**OFFICE OF RATEPAYER ADVOCATES
CALIFORNIA PUBLIC UTILITIES COMMISSION**

**Report on the Results of Operations
for
Pacific Gas and Electric Company
Test Year 2015
Gas Transmission and Storage Rate Case**

**Chapter 4A
Hydrotest and
Vintage Pipe Replacement Programs**

6 **Figure 4C-1**
 7 **Declining Hydrotest Unit Costs Based on PSEP Reported Costs**

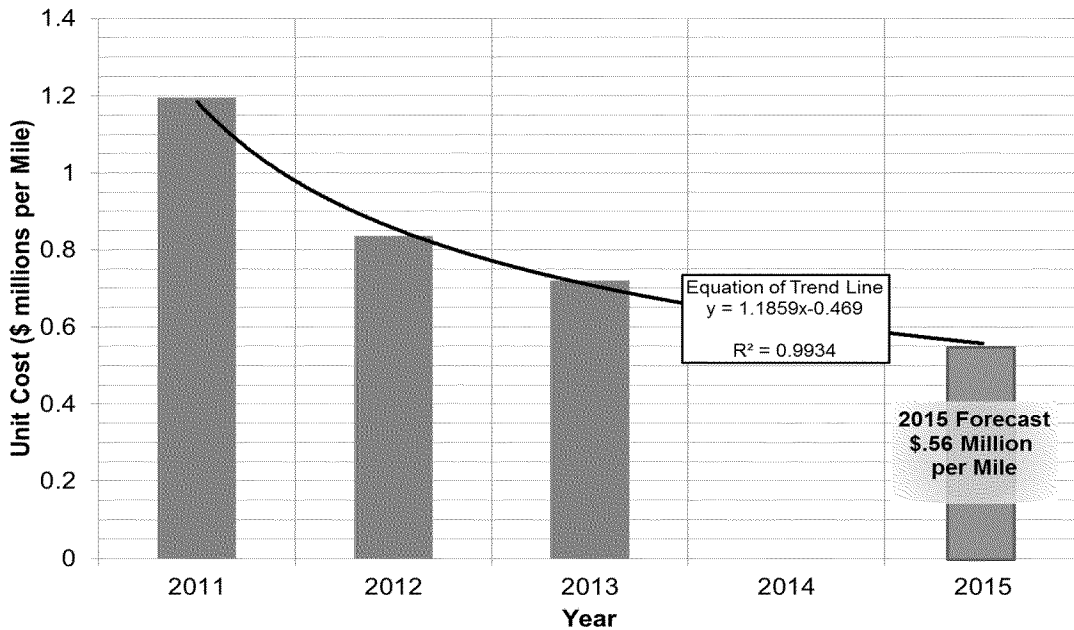
1 hydrotest costs between 2011 and 2013.⁶⁴ Such a trend is to be expected when a new
 2 program is commenced and the company experiences a learning curve. The following
 3 figure illustrates this trend, and extrapolates costs out two years to provide forecast
 4 costs for 2015 that take into account the likely continuation of the declining hydrotest
 5 cost trend:

8
 9 This figure, using recorded 2011, 2012, and 2013 costs from PG&E discovery
 10 responses as shown in Table 4C-4, extrapolates a 2015 cost of approximately \$0.56
 11 million per mile using a trend line based on a power equation.⁶⁵ The power equation is
 12 a form of “experience curve” which describes how costs decline as experience
 13 increases. The ORA Exhibit 4C Workpapers show that this equation provides the best

Figure 4C-2
Comparison of Various Price Indices Between January 2011 and June 2014

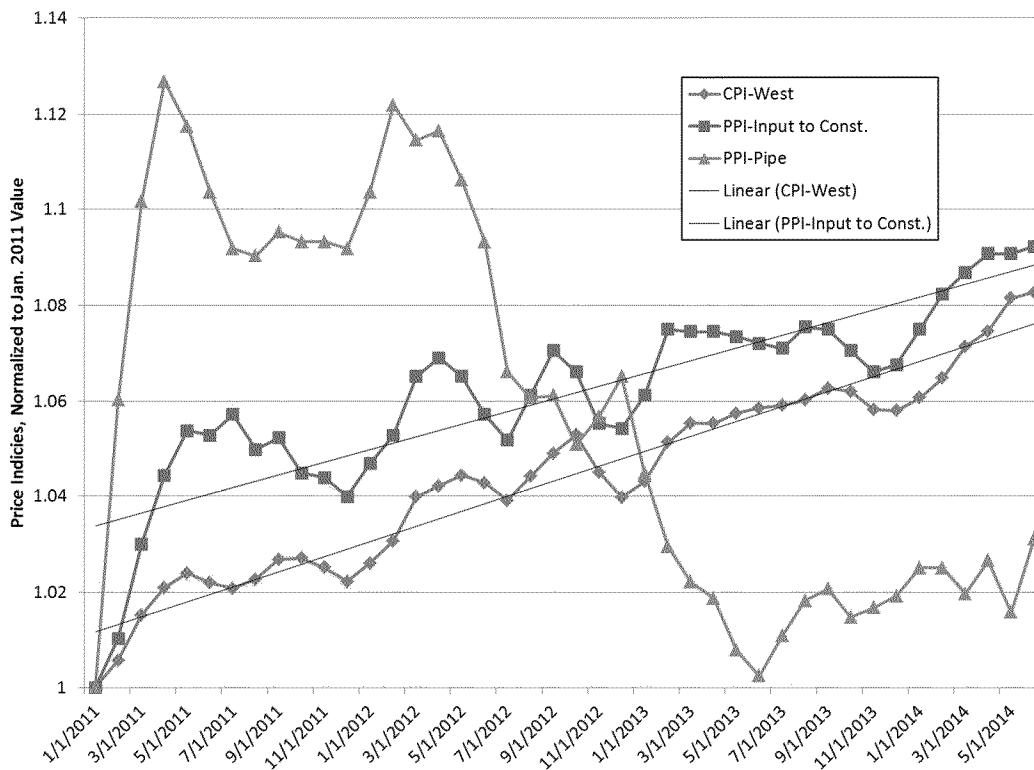
5 This data shows overall prices rising on average approximately 1.6% to 1.9%
6 annually through this time period.¹⁴⁴ These rates are lower than the escalation rates
7 PG&E used in its forecast of 2015 capital costs of 1.92%, 2.51%, and 2.39% for 2012,
8 2013, and 2014 respectively.¹⁴⁵ In addition, Figure 4C-2 shows that the price index for
9 steel pipe does not increase at a linear rate and has risen less than 2% over the entire
10 3.5 year period. ORA testimony in the PSEP proceeding indicated that pipe material, all
11 of which are steel, represented 27% of the variable cost for 10" pipe replacement and
12 45% for 36" pipes, and is thus a significant driver of replacement cost.¹⁴⁶ PG&E

**Figure 4C-4
PG&E VIPER Program Decision Tree**

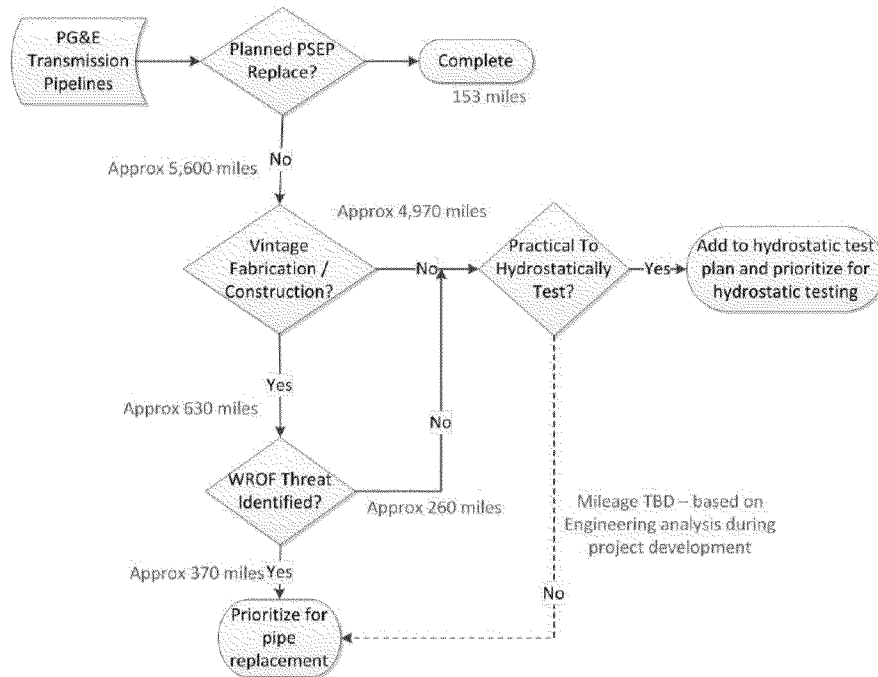
21 PG&E’s lack of transparency regarding deferred PSEP work is most clearly
22 illustrated by the proposed GT&S VIPER decision tree, in which the first decision point
23 fails to account for work that was planned and prioritized for replacement during PSEP,

1 but that was not completed. The following figure depicts the flow of projects through the
2 VIPER decision tree.¹⁶⁷
